BCA Design Assessment Report

St Joseph's College
Physical Education &
Sports Precinct Project (PESPP)

Project: St Joseph's College Physical Education & Sports Precinct Project
 Document Type: BCA Design Assessment Report
 Report Number: P217_362-2 (BCA) LS

Figure 1 – Firewall location which separates the building into two separate compartments

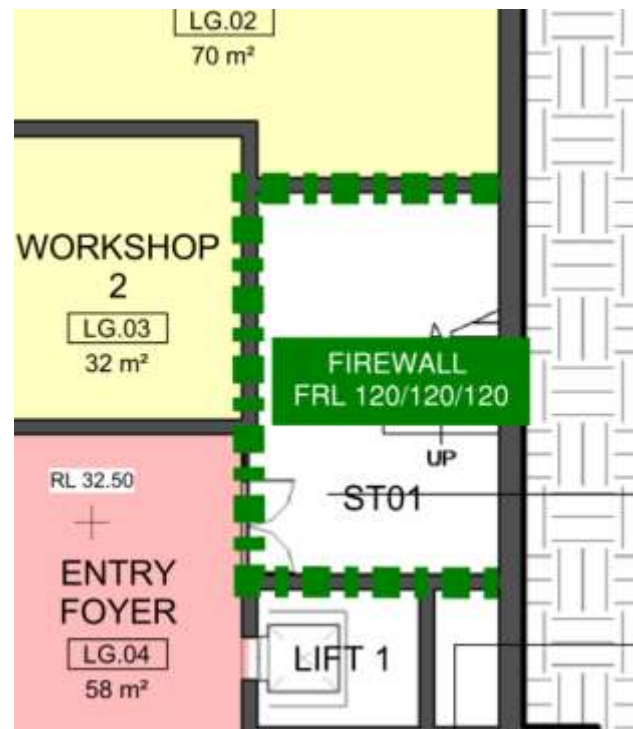
To ensure the subject building is within the maximum floor area and volume limitations prescribed within C2.2, the building is to be separated into two (2) separate / individual fire compartments.

The subject compartments are to be separated via construction achieving an FRL of not less than 120/120/120.

It is recommended that the compartmentation occur at the lower ground floor level, refer to Figure 1 below.
